SERVICE BULLETIN

APPLICABILITY: 2012-15MY Impreza 2.0L Models
2013-15MY XV Crosstrek Models

NUMBER: 12-194-15
DATE: 11/11/15

SUBJECT: Eliminating Gap between Headlamp and Bumper Cover

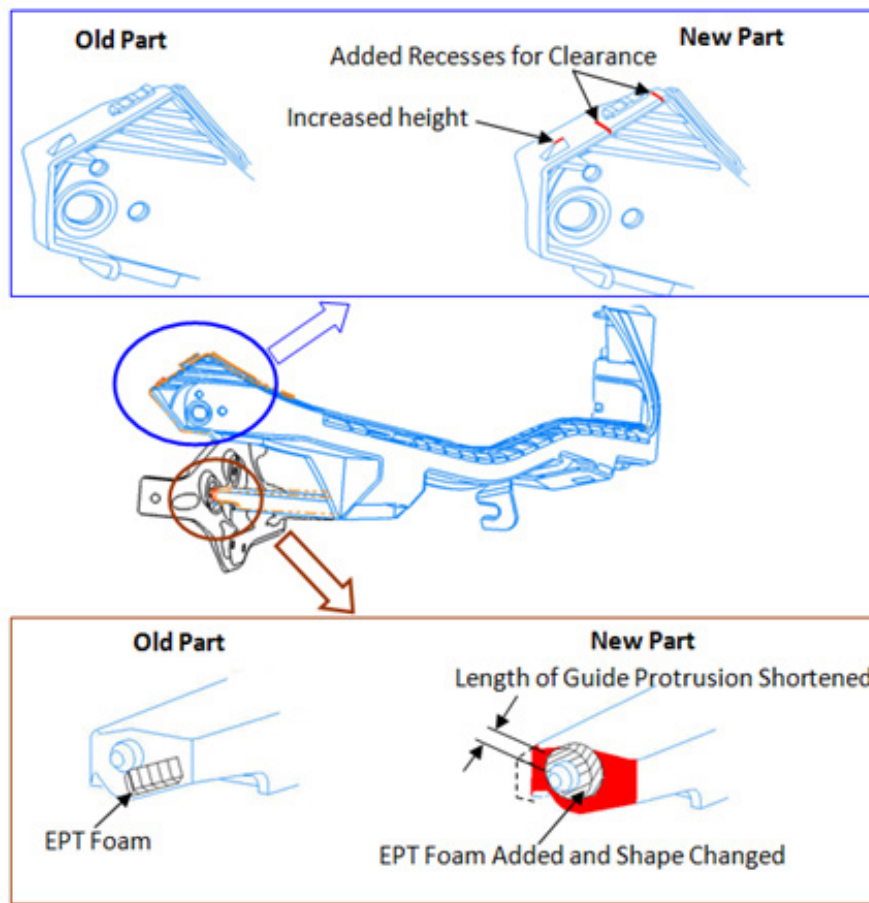
This bulletin announces a design change to the front bumper corner mounting bracket to address concerns of a gap between the top edge of the cover and the headlamp assembly as shown below.

The new bumper corner brackets were incorporated into production per the table below:

DESCRIPTION	NEW PART NUMBER	APPLICATION	OLD PART NUMBER
BRACKET FRONT BUMPER CORNER	57707FJ001	R/ HAND	57707FJ000
	57707FJ011	L/HAND	57707FJ010
